From: Benzie, Richard (DEQ)
Sent: Friday, October 02, 2015 4:01 PM
To: Cook, Pat (DEQ)
Subject: FW: Flint schematic in OEL

From: Crooks, Jennifer [<mailto:crooks.jennifer@epa.gov>]
Sent: Friday, October 02, 2015 12:46 PM
To: Busch, Stephen (DEQ); Prysby, Mike (DEQ); Rosenthal, Adam (DEQ); Benzie, Richard (DEQ)
Cc: Poy, Thomas
Subject: Flint schematic in OEL

If you need a schematic for the Flint water treatment plant, there's one included in the August 2015 OEL report posted on City of Flint's website.

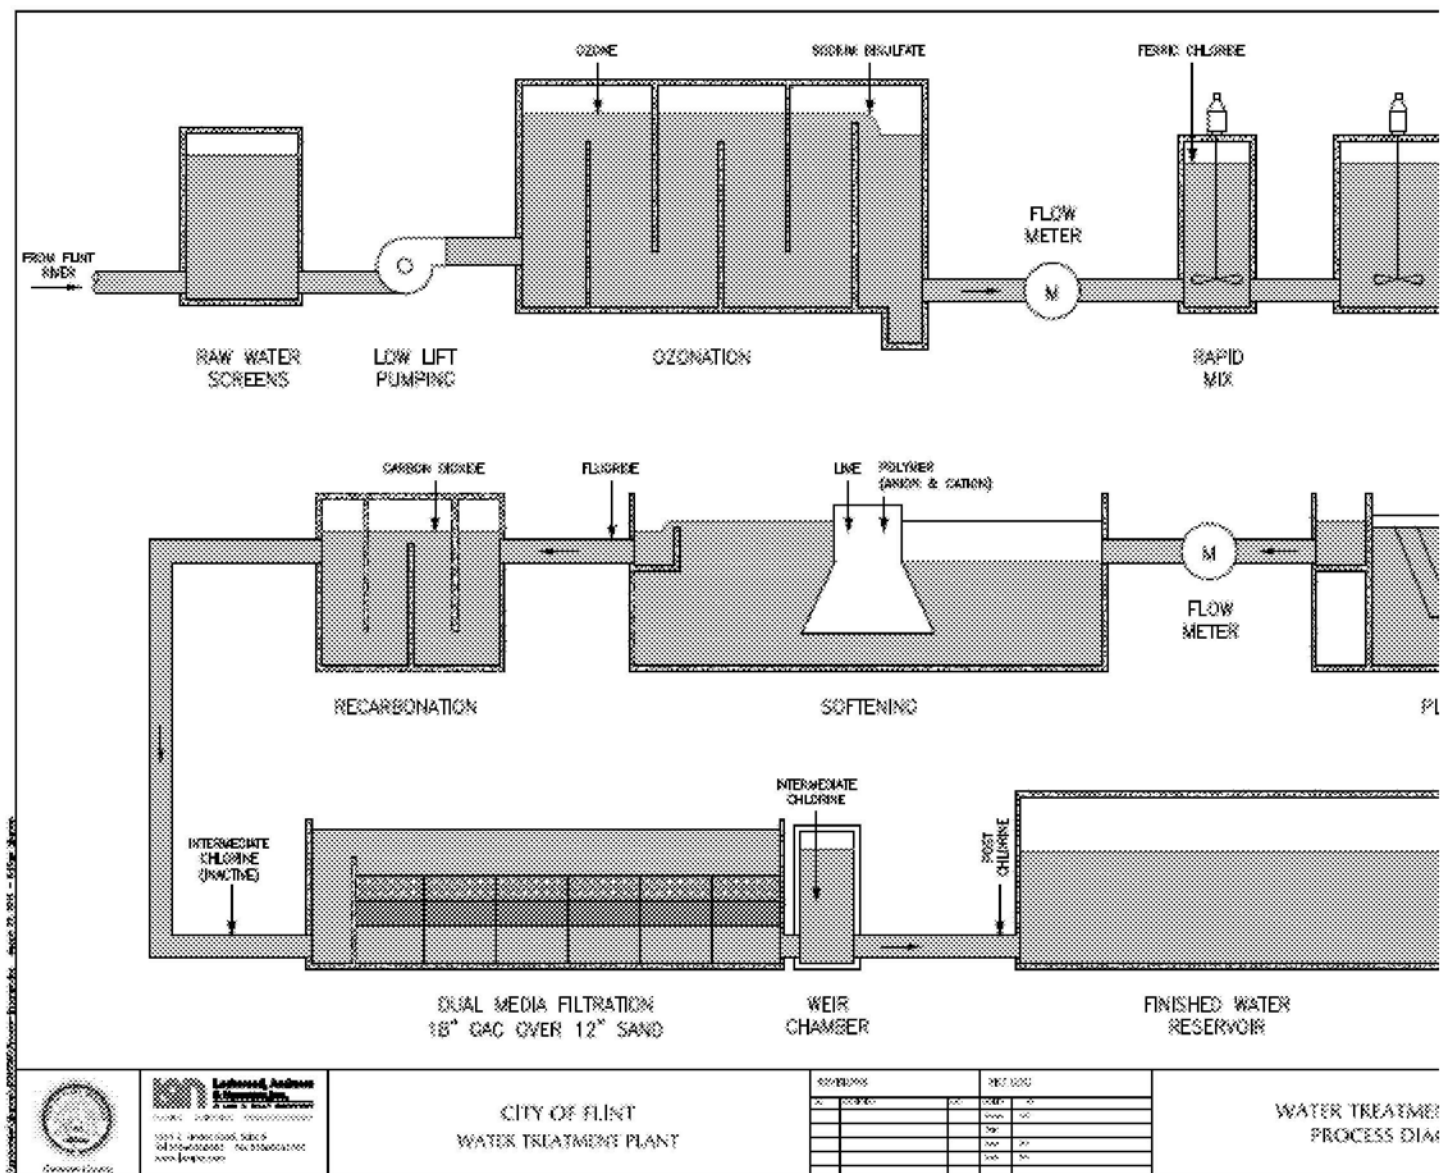
Have we routinely allowed filter plants to have only 12-inches of sand in there dual-media filters?
